**PLANNING COMMISSION
SITE PLAN WAIVER REQUEST REVIEW SHEET**

CASE: SP-2013-0175C

PROJECT NAME: Cirrus Logic Research Facility

DATE: September 25th, 2013
TO: Chair and Members of the Planning Commission
CC: Donna Galati, Case Manager
FROM: Caleb Gutshall, Transportation Review
SUBJECT: Waiver Request for Cirrus Logic Research Facility SP-2013-0175C

SITE PLAN

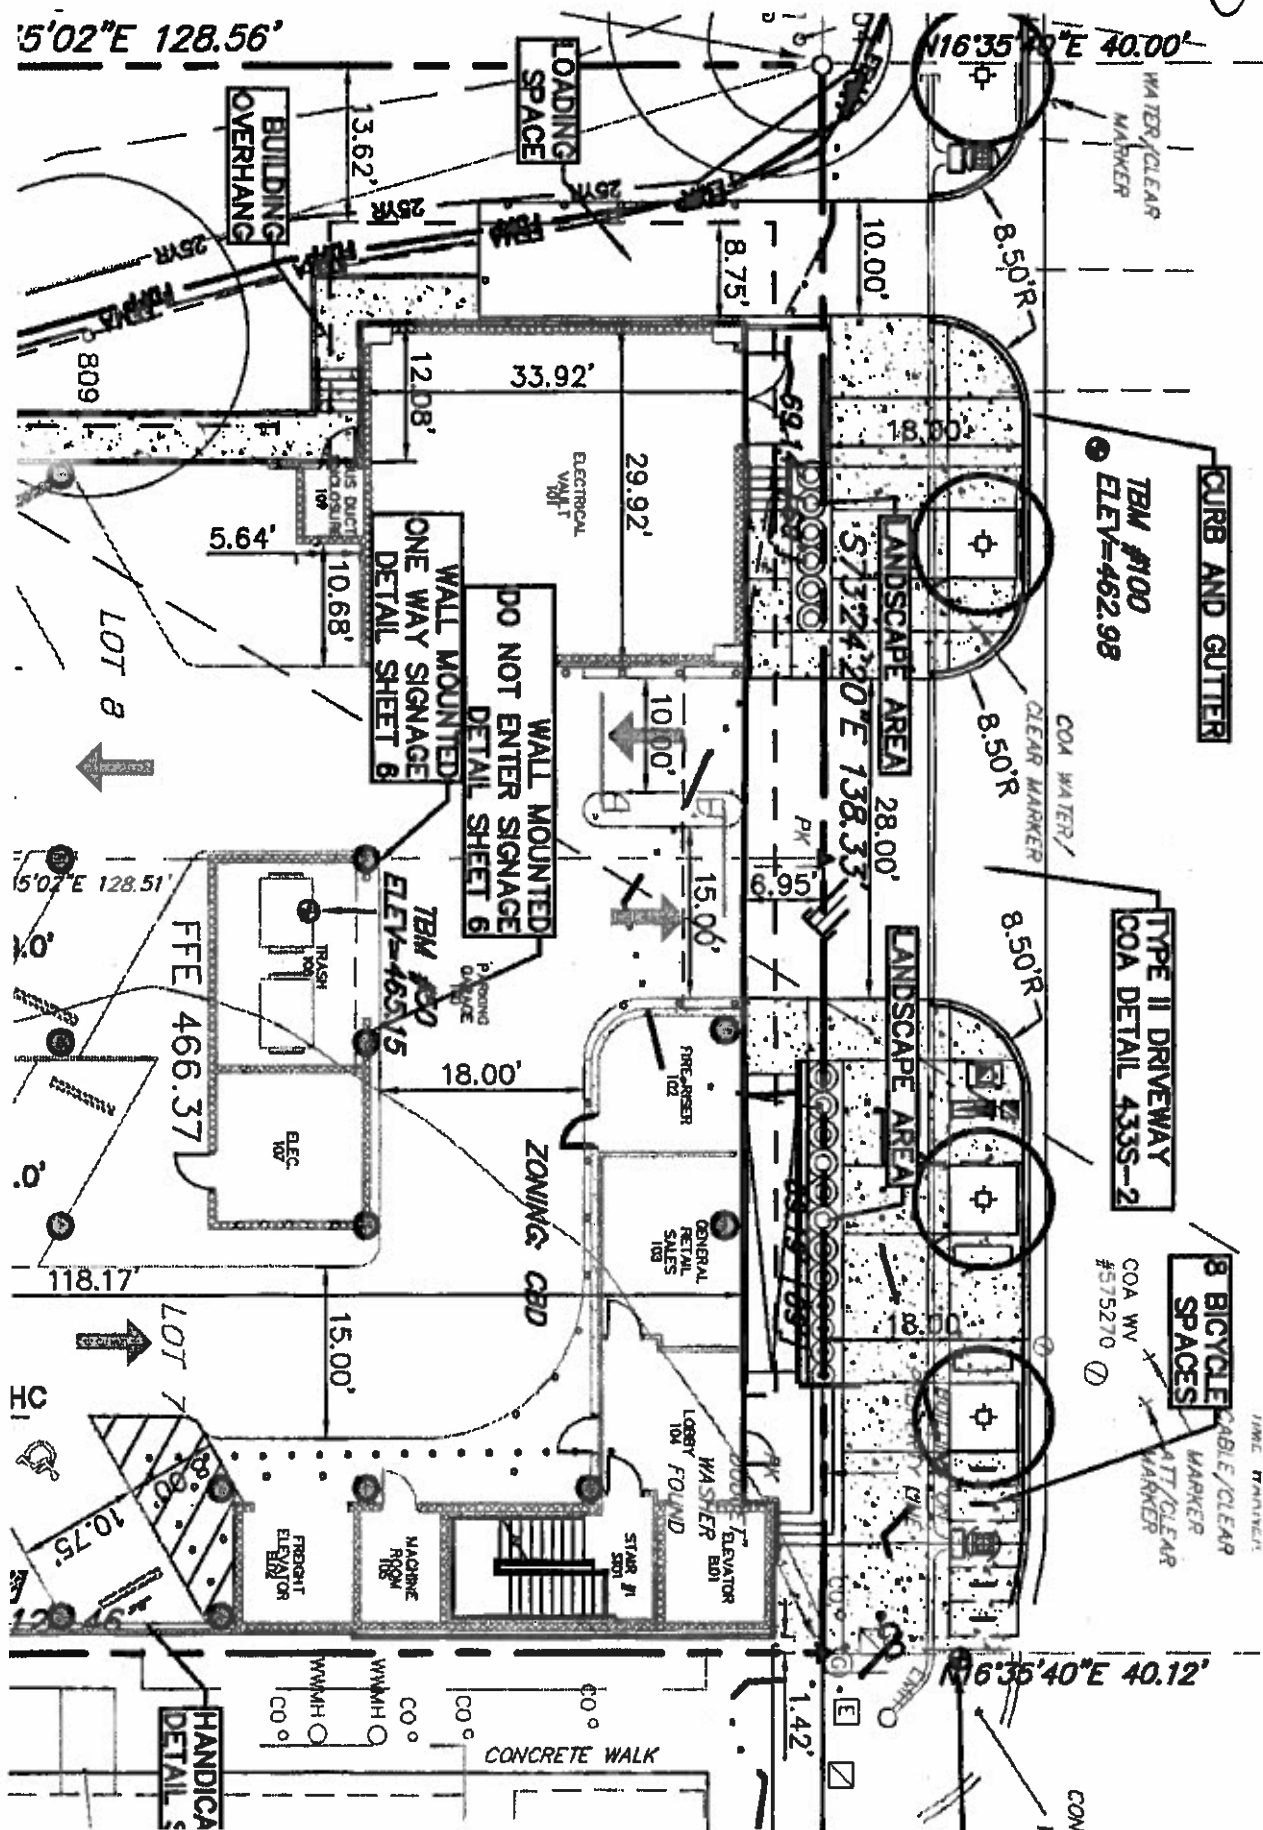
Land Use: The applicant is requesting a waiver from having a pedestrian use separating the ground-floor parking from W. 4th St. The proposed uses adjacent to the street are either required by other agencies (electric vault and fire riser room) or otherwise serve pedestrians (lobby and elevator for the upper level research services use). The site plan otherwise complies with land use regulations.

This administrative site plan will comply with all applicable requirements of the Land Development Code prior to its release. Staff recommends approval of the waivers.

AUTOTURN - LOADING SPACE
DELIVERY TRUCK MANEUVERING

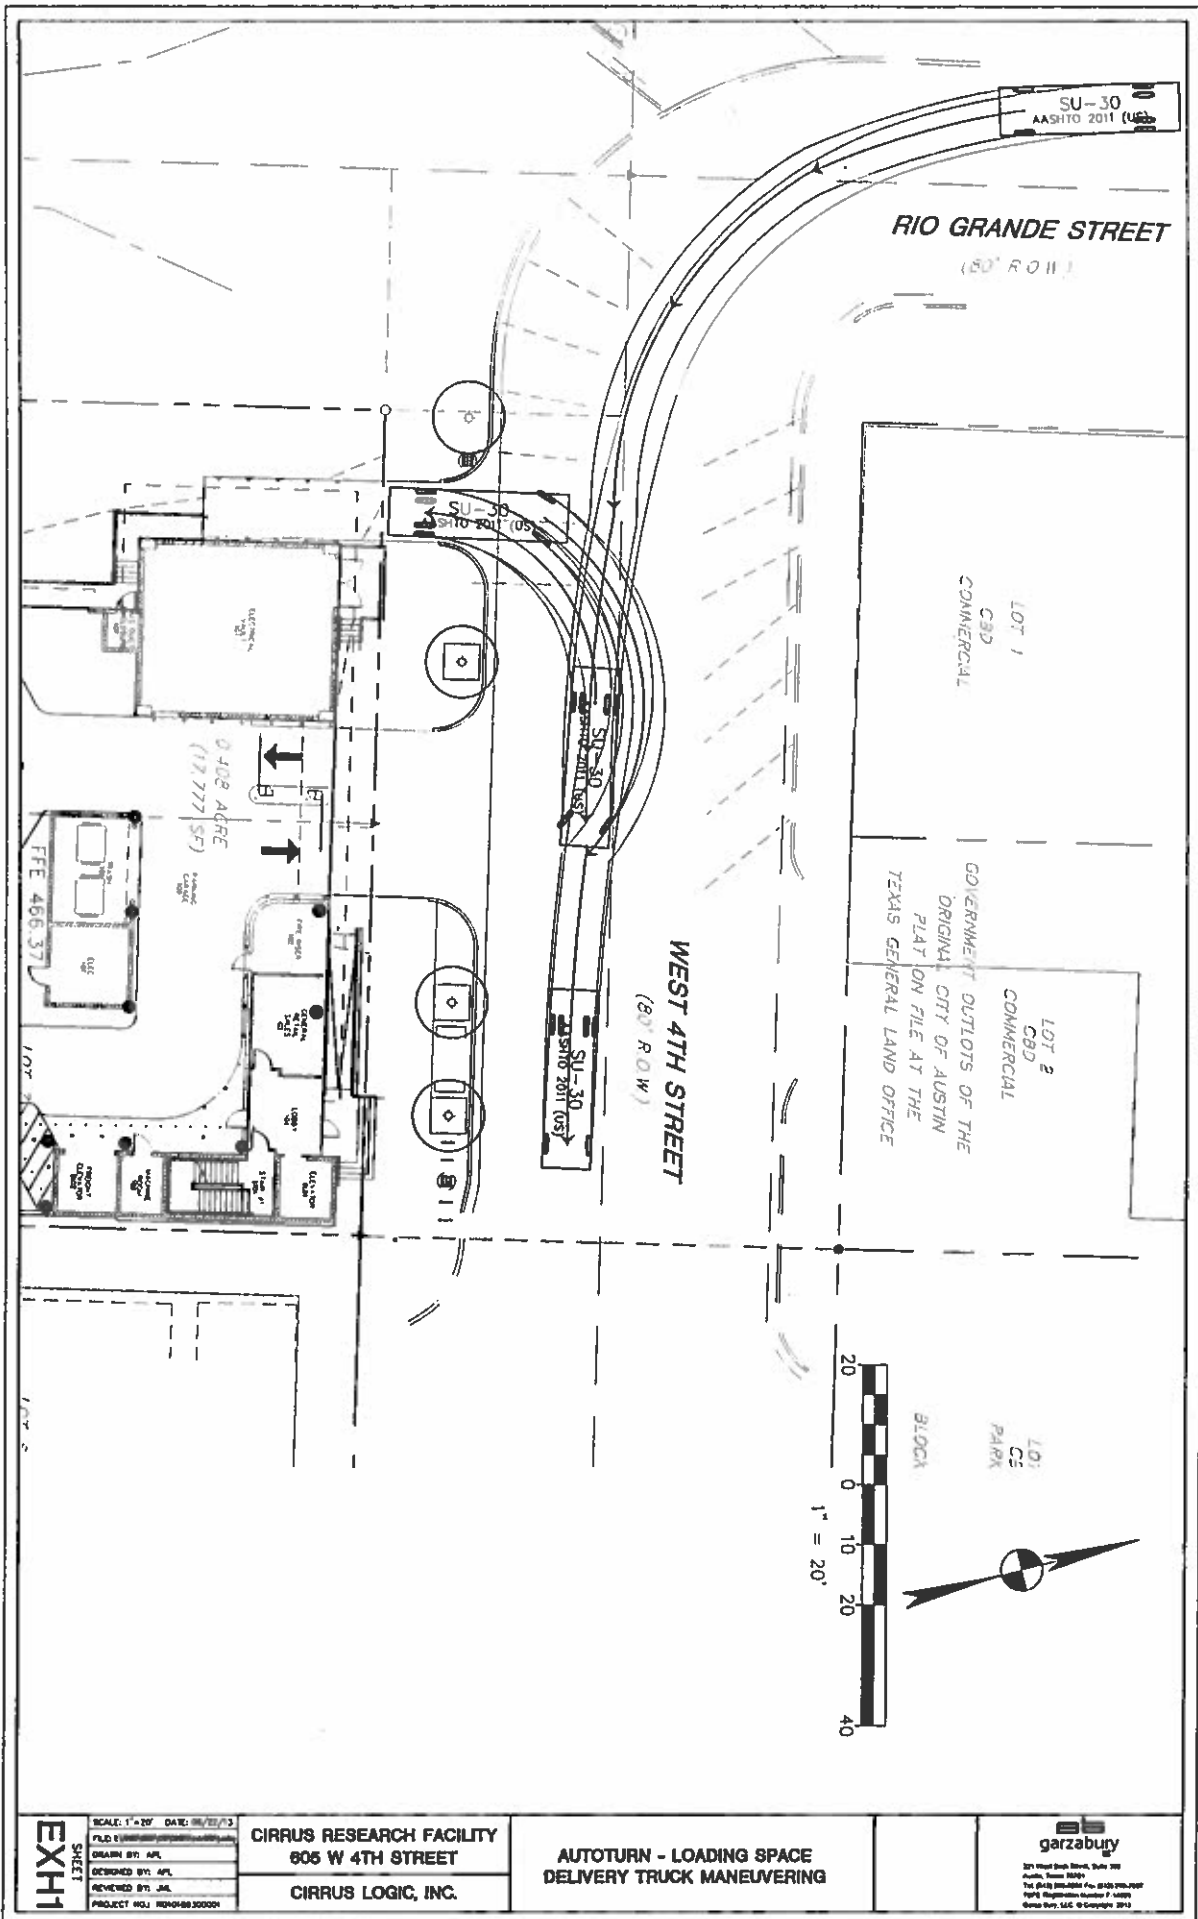
The proposed loading facility will be located on the west side of the building along West 4th Street. Given the small site area and design, it will be necessary for trucks to use the right-of-way in order to back out of the space, because the site is not located adjacent to a functioning alley. West 4th Street terminates at Rio Grande Street west of the site. The cyclists and minimal vehicles that use these roadways already decelerate to accommodate the right-angled turn. Due to the slopes along Shoal Creek, sidewalks do not exist west of the site along the south side of West 4th Street. The majority of pedestrians utilize the sidewalks along the north side of the street

We are proposing that the delivery trucks back into the loading space, which is a protected space with no traffic, rather than pulling into the loading space and then backing out into 4th Street, which is an unprotected space with traffic. The attached Exhibit 1 shows the loading space maneuvering movements.

The Transportation Review Section recommends the waiver be granted with the following conditions:

- Establish dock policies to ensure that the deliveries are scheduled by appointment.
- Schedule deliveries at off-peak times to the maximum extent possible in order to minimize potential traffic, bike, and pedestrian conflicts.
- Keep an employee/ attendant to guide delivery trucks in the loading docks to ensure safe maneuvering in the right-of-way.
